ADDENDUM NO. 1

DATE: June 24, 2020

**For
DYPSKI PARK IMPROVEMENTS
CONTRACT NO. RP 17802**

FOR THE MAYOR AND CITY COUNCIL OF BALTIMORE

1 COMFORT STATION PLAN AT LEAKIN PARK (2000 SLOMAN DRIVE)
A1.4 SCALE: 1/2"=1'-0"

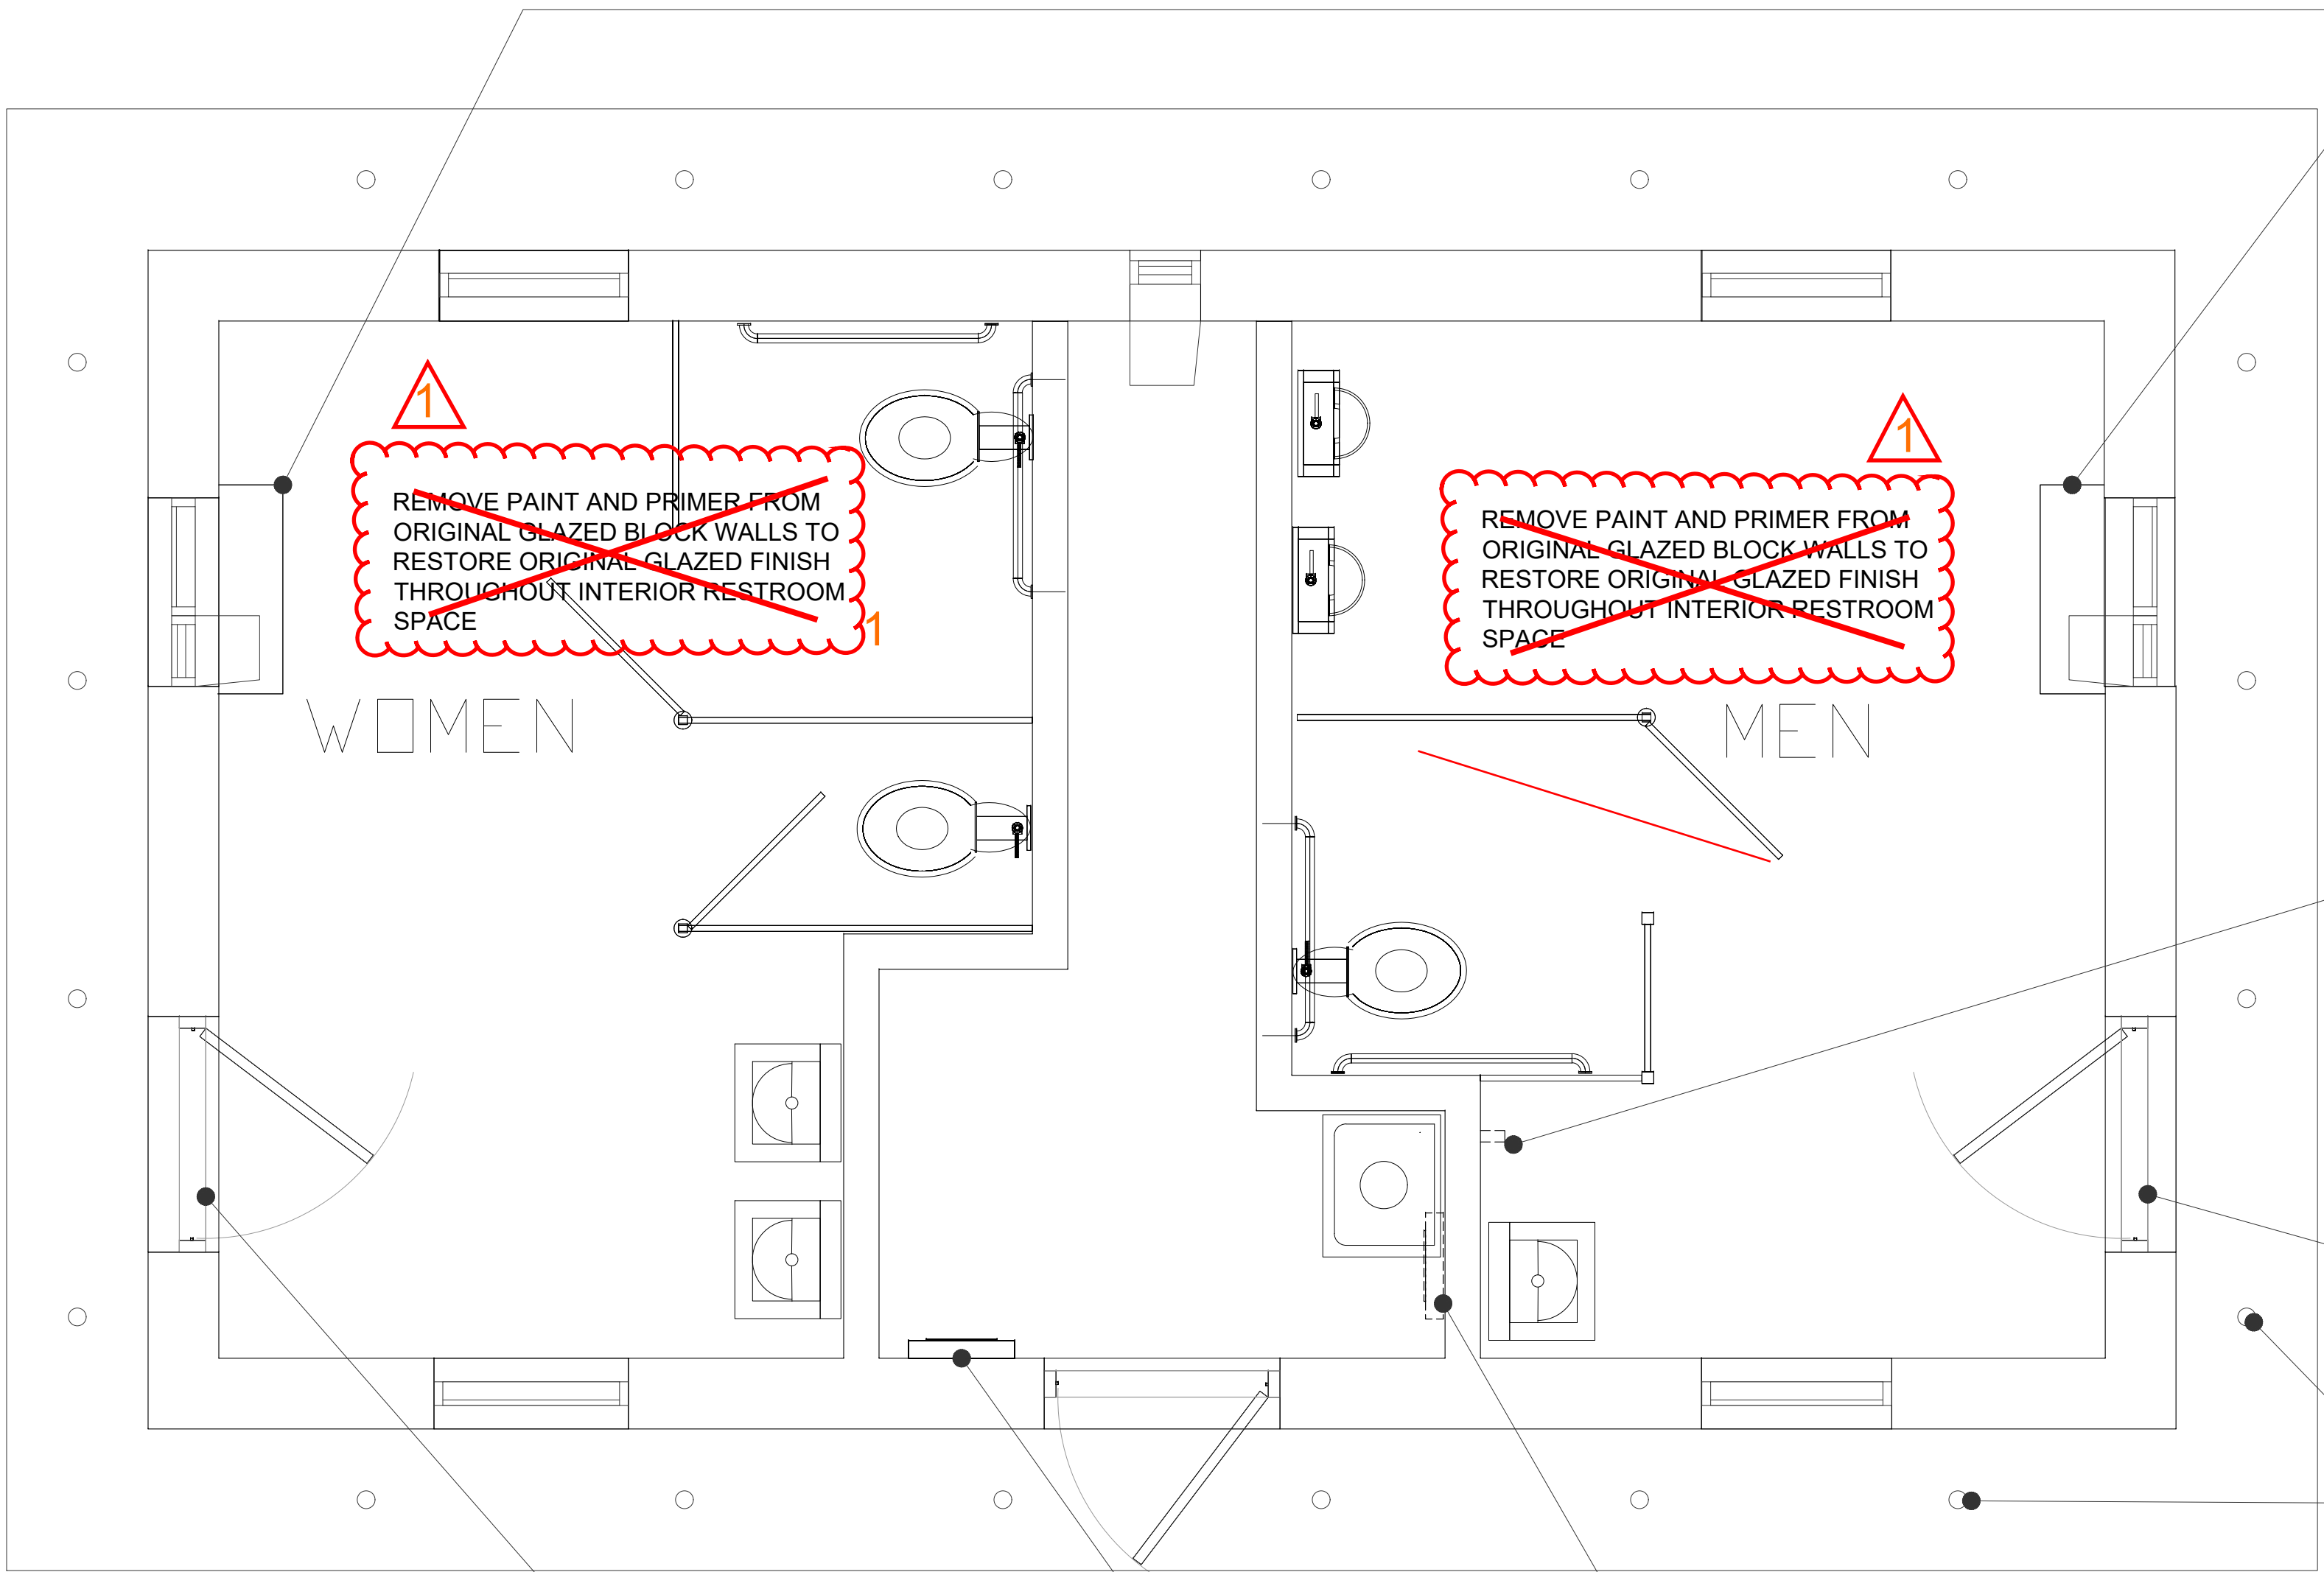
QUESTION 2: On the drawings Volume 2 for the work at Gwynns Falls Leakin, on Sheet A1.4 there are notes in the both the Mens and Womens restrooms that say "Remove paint and primer from original glazed block walls to restore original glazed finish throughout interior restroom space. We're under the impression that those restrooms walls were recently newly painted when the restroom building renovations were recently performed. Our opinion is that it would cost quite a bit to remove all of the paint throughout the rooms and the benefit may be marginal. If the restroom building was renovated there could be a lot of underlying patching that was performed on the glazed block walls prior to the application of the primer and finish coats of paint. The work of removing the paint could end up exposing the underlying patching. If the intent is to have a glazed finish on the wall that is more washable it may be less expensive and give a better result to select a glazed paint coating to be applied to the wall surfaces.

ANSWER: **DELETE** from scope of work to "remove paint and primer from the original glazed block walls to restore original glazed finish throughout interior restroom space" of the comfort station at Leakin Park. Also, see revised sheet A1.4- Comfort Station Improvements", **DELETE** removal of paint and primer and to restore original glazed finish throughout interior restroom space (for both Mens and Womens restrooms).
